ENGINE - LP COMPRESSOR - REWORK THE NO.1 BEARING SEAL ASSEMBLY TO INCORPORATE A REVISED SLEEVE SPACER AND RETAINING COLLAR - CATEGORY CODE 6 - MOD.ENG-72-0082

V2500-ENG-72-0082

Location of No.1 Bearing Seal Assembly
Fig.1

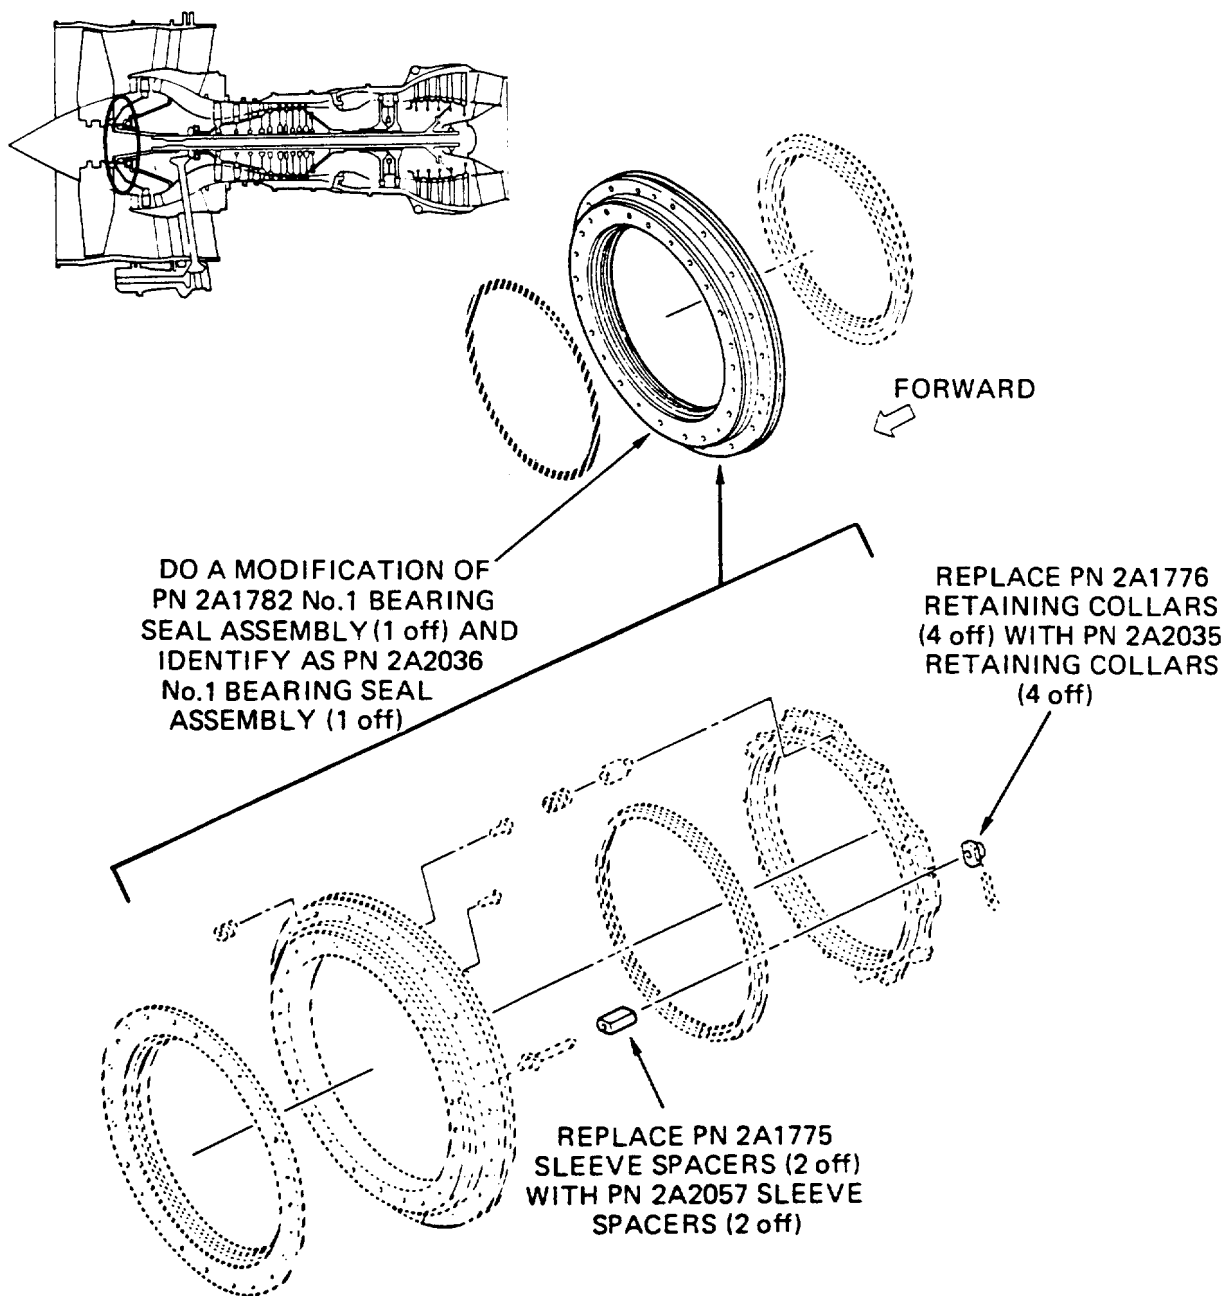
- (1) Assemble the No.1 Bearing Seal Assembly by Figure 1 and approved procedure in Reference (1), Chapter/Section 72-32-53, except:
 - (a) Install 2A2057 Sleeve Spacers (2 off) on the two pins that are almost 90 degrees from both sides of the offset pin.
 - (b) Install 2A2035 Retaining Collars (4 off) on the pins.
- (2) Identify 2A1782 No.1 Bearing Seal Assembly as 2A2036. Refer to Reference (2), Chapter/Section 70-09-00, Marketing of Parts. Use the vibration peen method.
